Brisbane Central Business District Bicycle User Group

**Brisbane Central Business District Bicycle User Group (CBD BUG) submission re
Development Application: A006099651 - 3 Boundary St Brisbane City Qld 4000**

Figure 1: Overhead view of bollard hazard and informal storage with gate typically left open

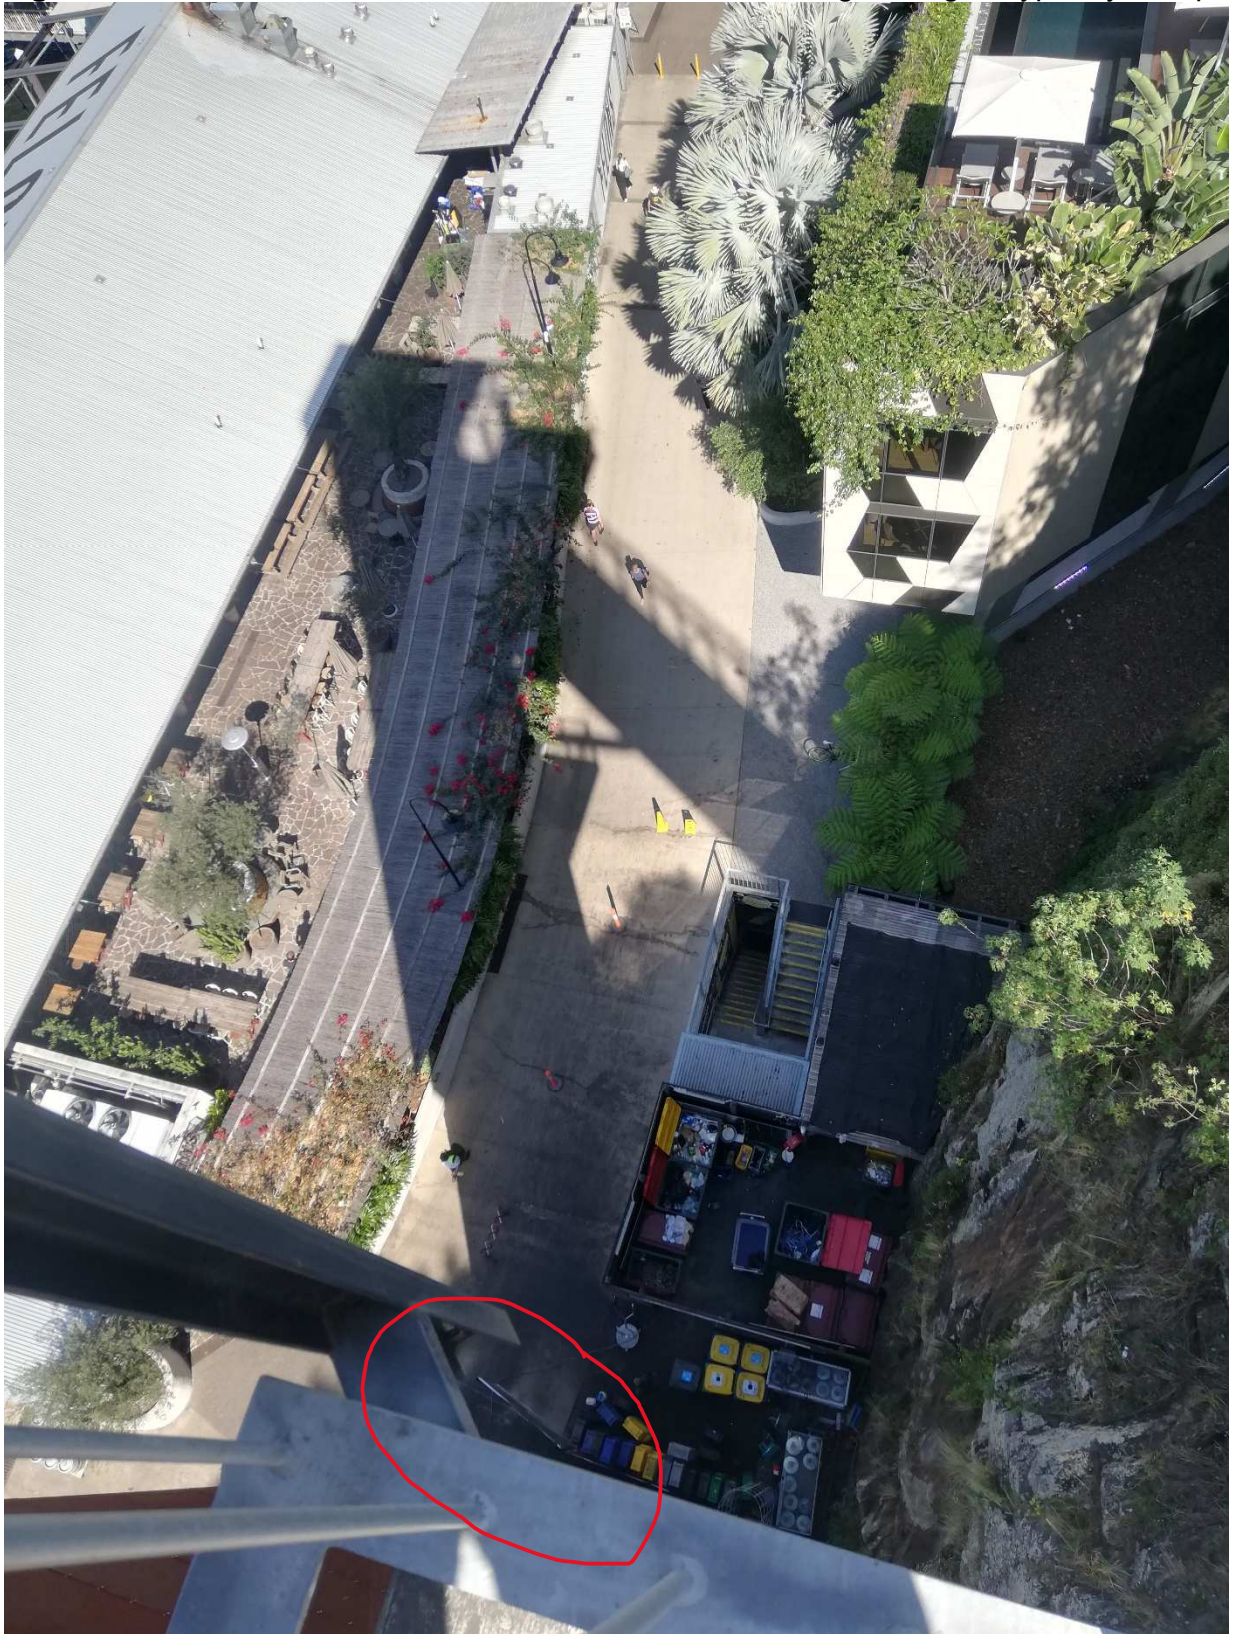
Furthermore, since the redevelopment of the HSW precinct the developer has displayed a neglect, if not contempt, for the amenity and safety of the community members simply wanting to travel to or from the CBD via this site. Figures 1 to 3 at the end of this submission show just some of the instances of this routine behaviour. Sadly, this too has been allowed by a supine Brisbane City Council (BCC). While there are numerous examples of BCC's lax attitude in controlling development of this precinct, a key example is how key recommendations from Council's own engineering team on 15 October 2018 (in relation to DA A004897686) were almost completely ignored.

The removal of the low bollards, which represent a hazard, and should not have been installed in the first place, is welcomed. The addition of the timber rail fence would also seem to represent a welcome safety improvement.
